# Access Compliance Report

## Public Rights-of-Way

### (Pedestrian Signals)

Intersection ID: N/A	Main Street:	Cross Street: N/A	Location: N/A
ADA ID: 969C0CE08454	Signal Type: One Push Button-APS	Overall Compliance: No	Severity Score: BTN 1: N/A BTN 2: N/A No BTN: N/A
Codes/Mitigation Info/Possible Solution		Field Measurements/Component Compliance

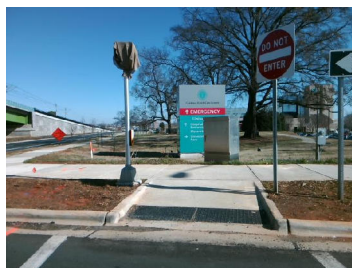
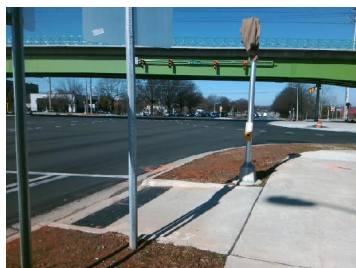
Surveyor Notes: NOT HOOKED UP, NOISES  
AND VERBAL COMMANDS UNKNOWN

Possible Solutions: Remove & Replace  
Replace APS Button With New APS Button.  
Remove and Replace Clear Space.
